*Proceedings of the Madras Government, Judicial Department,
15th August 1866.*

PLAN of the JAIL at **BELLARY** SHIMING.

What is to be removed and the improvements
and additions proposed.

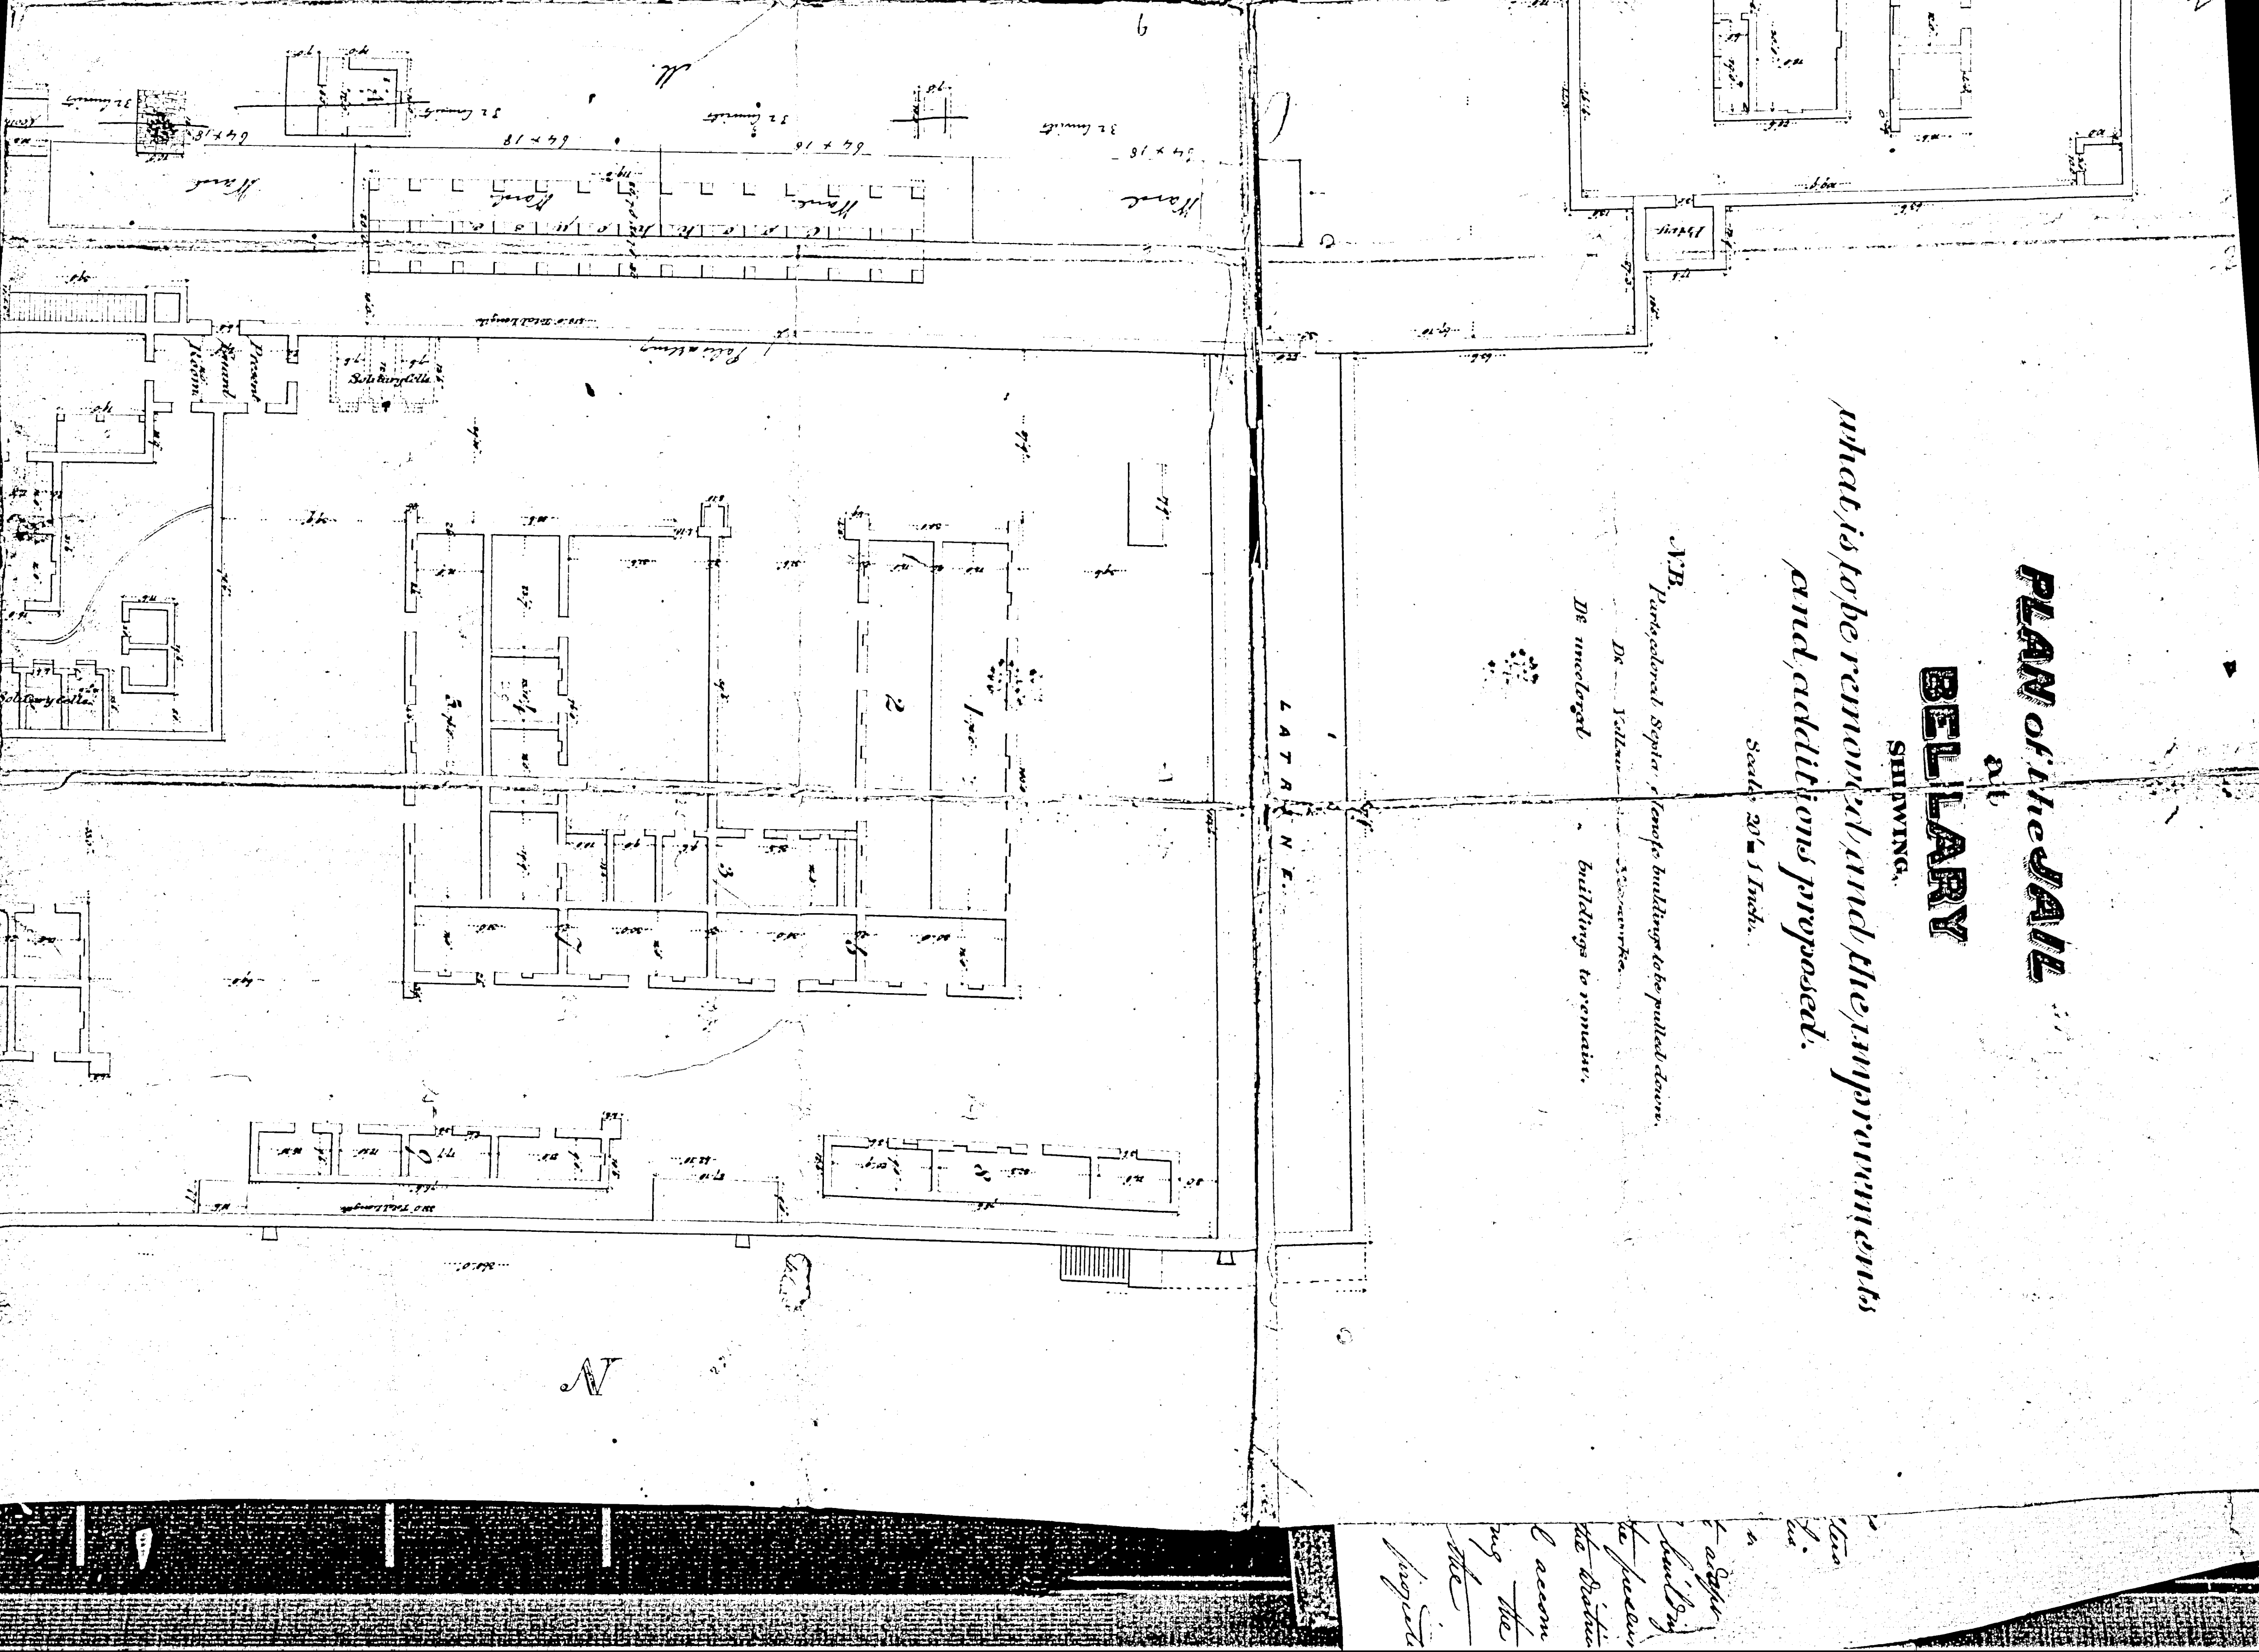
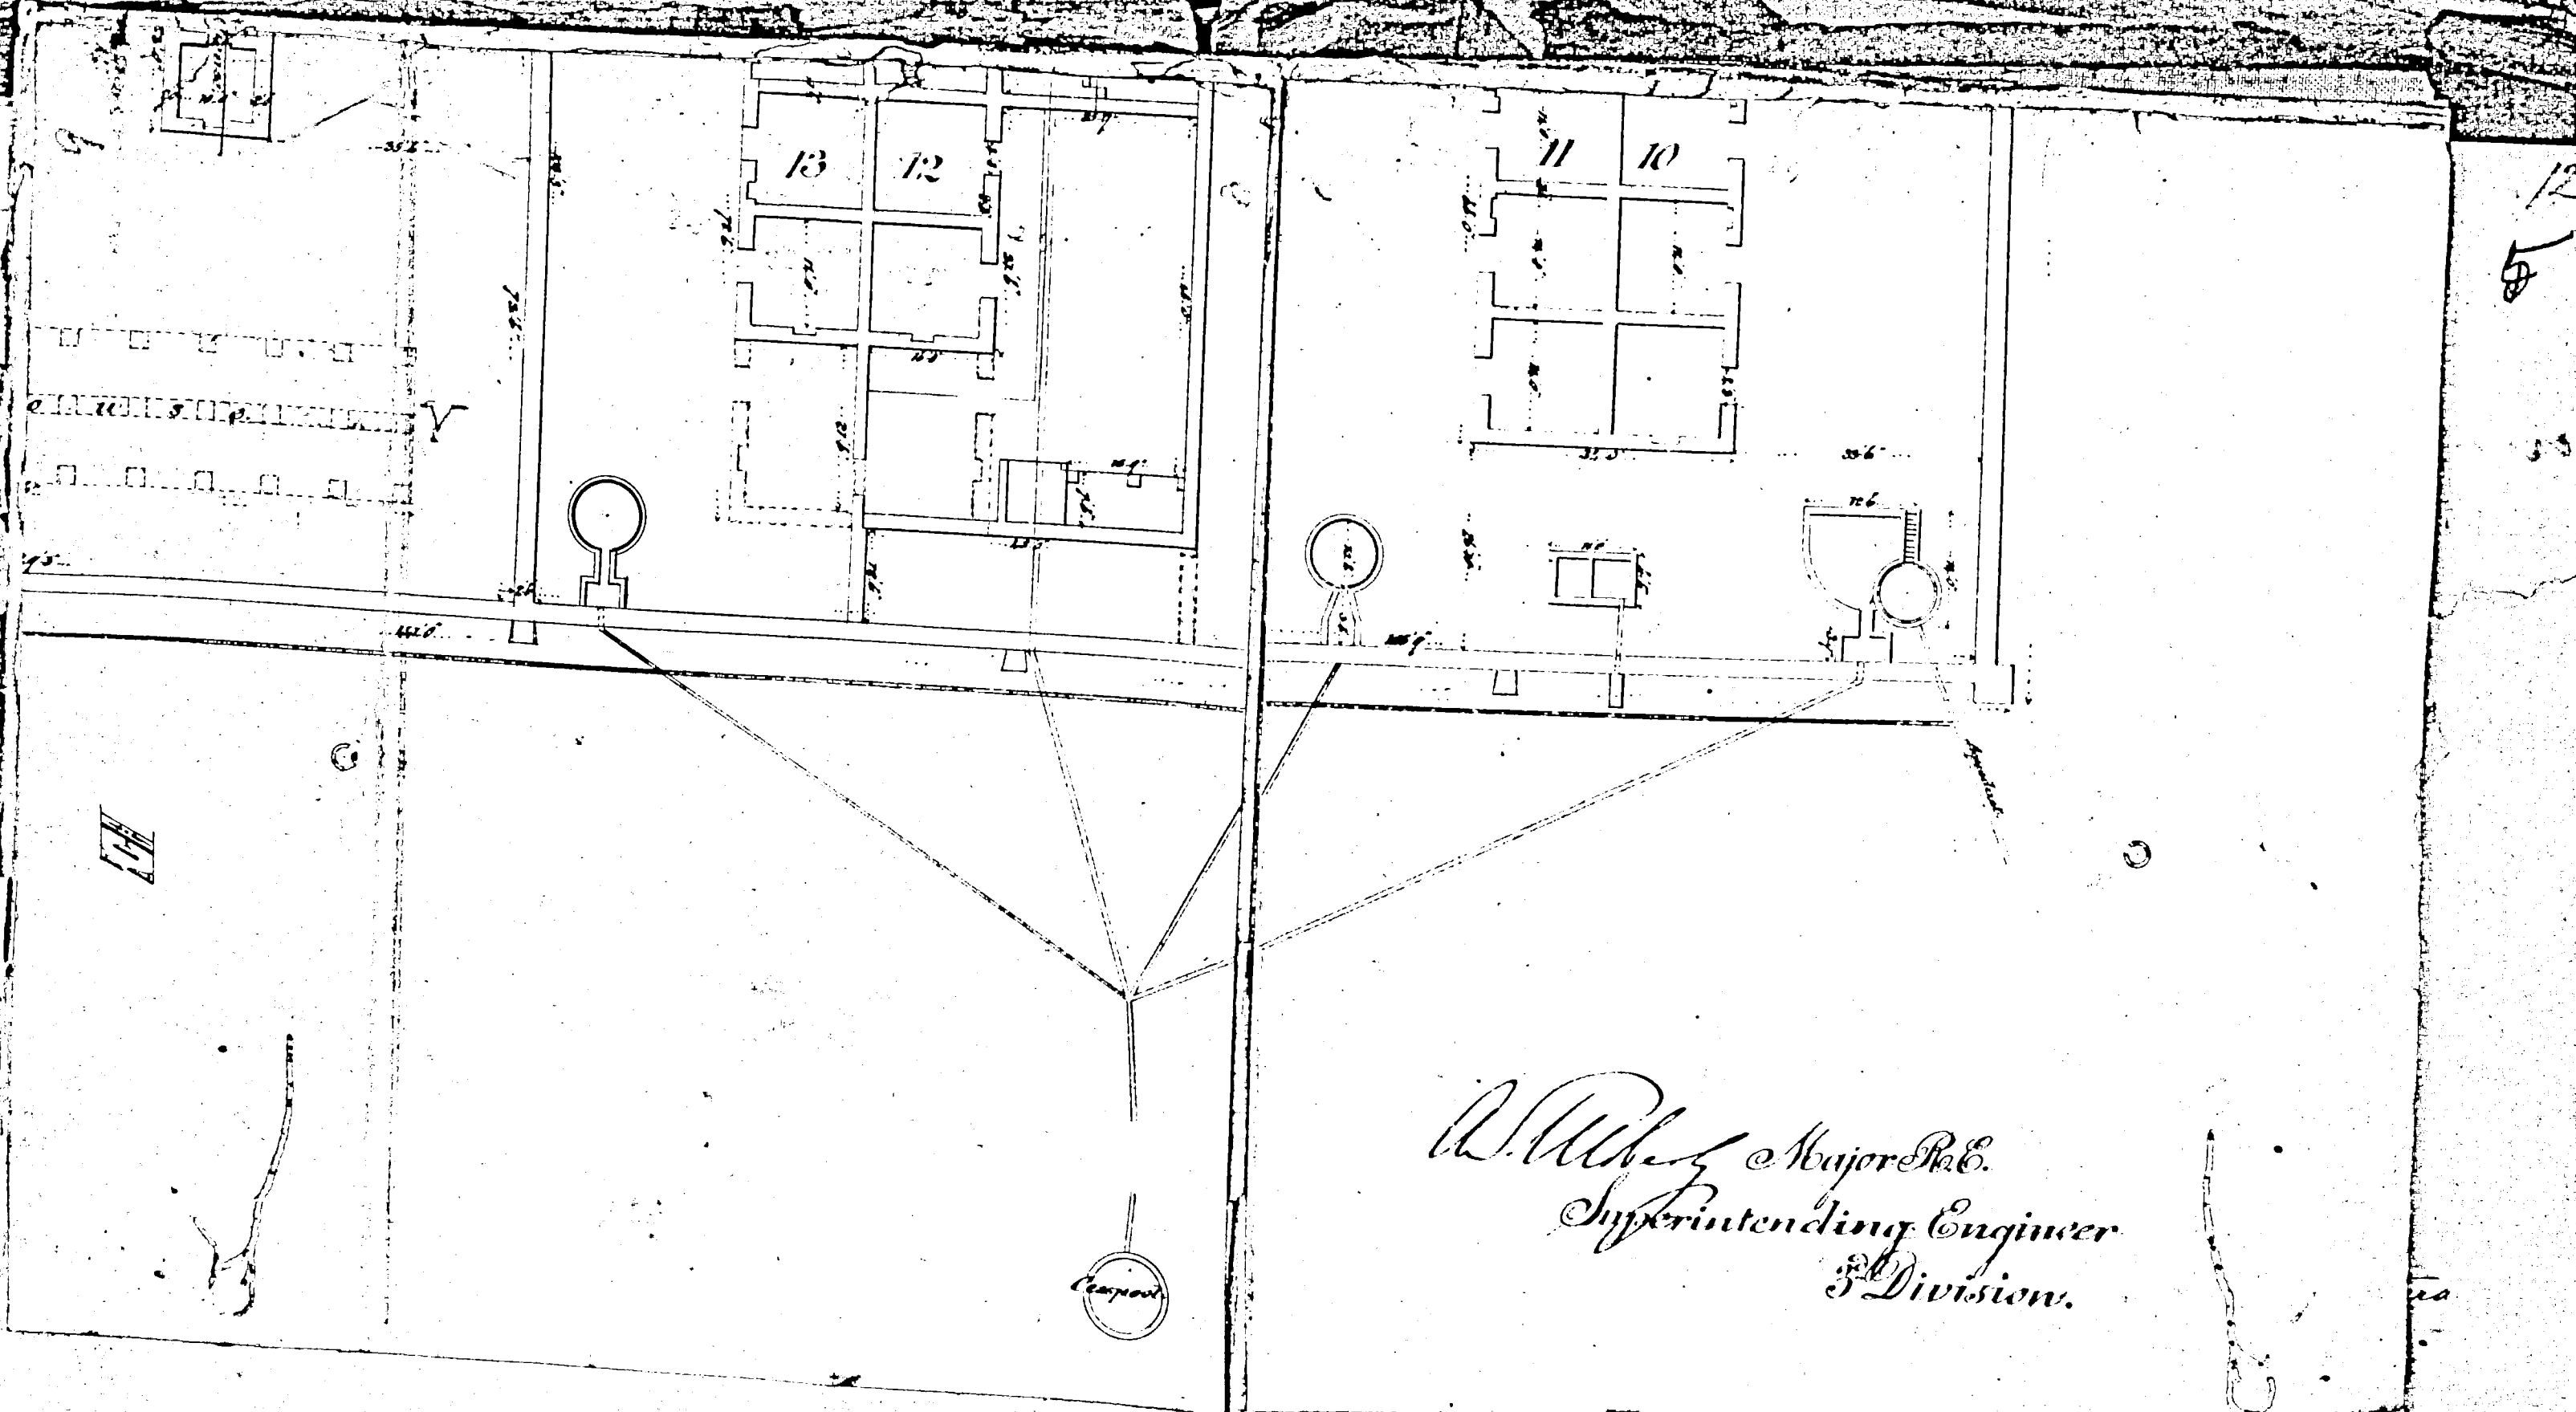
1st.—To raise the walls of all the wards, with the exception of Nos. 8 and 9, to 18 feet, in order to obtain the required accommodation for 275 prisoners.

2nd.—To throw down the wall intermediate between the original Jail gate (now in the centre of the enclosure) and the south-east corner of the Latrine, in order to admit of a more free perfusion of air. The Superintendent of Police raises an objection to this, on the ground of its increasing the area of the Jail, and thereby rendering an increase to the permanent Jail Guard necessary; but, in the event of this objection being considered valid, we would recommend that a palisade be put up in lieu of the wall, and thus, while a freer circulation of air is obtained, the area of the Jail is in no way interfered with.

3rd.—To throw down the wall between Cells Nos. 2 and 4.

4th.—To remove the present Solitary Cells to the site noted in the plan on the left of the old gate.

5th.—To throw down the old Sub-Court, as a building which can hardly be adapted to any useful purpose, and to which the Superintendent of Police has repeatedly objected, on the ground of its obstructing the thorough view of the Jail enclosure.

6th.—To throw down the wall now connecting the old Sub-Court with the store-rooms, as well as that intermediate between them and the Hospital enclosure, in order to admit of a more free circulation of air.

7th.—To enlarge the area of the Hospital enclosure by continuing the front wall on to the outer south wall, and by throwing down the wall running from east to west, in continuation of that mentioned in Clause 6.

8th.—To throw down the small Cells in rear of the Hospital, and to remove the two rooms now at the south-east corner of the enclosure, to occupy the middle of the site of the wall to be thrown down; this is considered requisite to obtain more free circulation of air in the Hospital area.

9th.—To erect a suitable Guard-House at the new entrance to the Jail for one European and 17 Natives. The guard is at present placed in the old gateway, but this place is not suitable by any means, and the reserve occupy a small room in the Sub-Court—this building, as mentioned before, we propose to knock down, so that there will then be no place for the guard beyond the old gateway.

10th.—The building A, is the only one now available for office purposes; but it is wholly unsuitable. It is proposed to erect a suitable one on the site marked on the plan.

Forwarded to the Superintending Engineer of the 3rd Division, with the remark that the Plan submitted, bearing his signature, has been very imperfectly prepared, and entirely fails to elucidate, in any degree, the report of the Committee. The undersigned accordingly requests Major Moberly to be good enough, in re-submitting the accompanying papers, to forward a detailed and carefully prepared plan, fully illustrative of the Committee's remarks and recommendations.

2. It was calculated by Messrs. Rohde and Ellis that, on the completion of the Central Jail, about 275 prisoners would remain to be provided for in the District Jail, and they proposed to afford the necessary accommodation by building two new wards within the Jail enclosure, each to contain 35 prisoners. The Bellary Committee propose to attain the same result by removing certain partition walls, by adding to the length of some wards, and by raising the walls of the whole to the height of 18 feet, with the exception of those of the buildings marked 8 and 9 in the plan.

ward to contain 32 prisoners, be erected within the Jail enclosure, at the spot marked M in the plan; the cook-room to be knocked down, and replaced by another of similar dimensions, to be built at the spot marked N. The old Sub-Court-house cannot possibly be spared at present. It may be easily adapted for the reception of prisoners, and I would advise that this be done at once. If, after the occupation of the Central Jail, it should be found that the accommodation at Bellary is in excess, it is sure to be useful in the way of relieving the Jail at Kurnool, which is frequently crowded, and which cannot be enlarged to any extent owing to its situation within the Town. Shortly before the recent out-break of Cholera at the last named place, I transferred 100 convicts therefrom to the Central Jail at Coimbatore, as I had no other means of disposing of them; but such a mode of relief is manifestly inconvenient.

4. It seems to me that to remove the roofs and to heighten the walls of the existing wards, while the Jail is inhabited, would be both a tedious and inconvenient operation, besides which, I am given to understand that the walls generally are fragile, being composed of unburnt bricks, and unlikely to stand the weight of the additional height proposed. Should it appear to Government that this method of improving the accommodation is worthy of adoption, it may be advisable, in the first instance, to instruct the Superintending Engineer to examine the walls carefully, and to report thereon. It is true that an Engineer Officer was a member of the Committee, but I have recently received a report from Nellore to the effect that certain alterations recommended by the Committee at that station cannot be carried out, owing to the weakness of the timbers and roof; and I have, therefore, thought it prudent to suggest the precaution above mentioned.

5. It is proposed to convert the buildings marked 8 and 9 into wards for the reception of prisoners suffering from leprosy or other contagious diseases, but I doubt the expediency of placing these persons in such proximity to the general wards, or of removing them so far from the Hospital. I would therefore allow the range of Cells behind the Hospital to stand for the present. They were built at the recommendation of the then Medical Officer, and sanctioned by the late Inspector General of Jails.

I. The construction of a new Barrack of four wards to contain 128 prisoners. The Barrack to be built of the rough stone of the country laid in mud, and pointed with chunam, to be tiled or terraced as may be found least expensive. Each ward to be 64×18 feet, and the arrangement of doors to be according to the lower of the two plans lithographed for the Public Works Department in August 1865.

II. The adaptation of the Sub-Court-house for the reception of prisoners.

III. The construction of one Guard-room at the outer gate, for the party of Police at present located in the Sub-Court-house.

IV. The erection of a cooking shed, in lieu of that at present in use.

V. The erection of an office, in lieu of the building marked A.

VI. The piercing of the walls of one of the rooms marked 14 or 15, in order to fit it for the reception of State Prisoners.

VII. The substitution of palisading for the wall between the guard-room and the south east corner of the latrine.

The Governor in Council approves of the additions and alterations proposed by the Inspector General of Jails in the foregoing letter, to adapt the existing Jail buildings in Bellary to the present requirements of the District in respect to Jail accommodation, pending the construction of the projected Central Jail at Vellore. Orders will accordingly be issued in the Public Works Department for the early execution of the improvements in question.
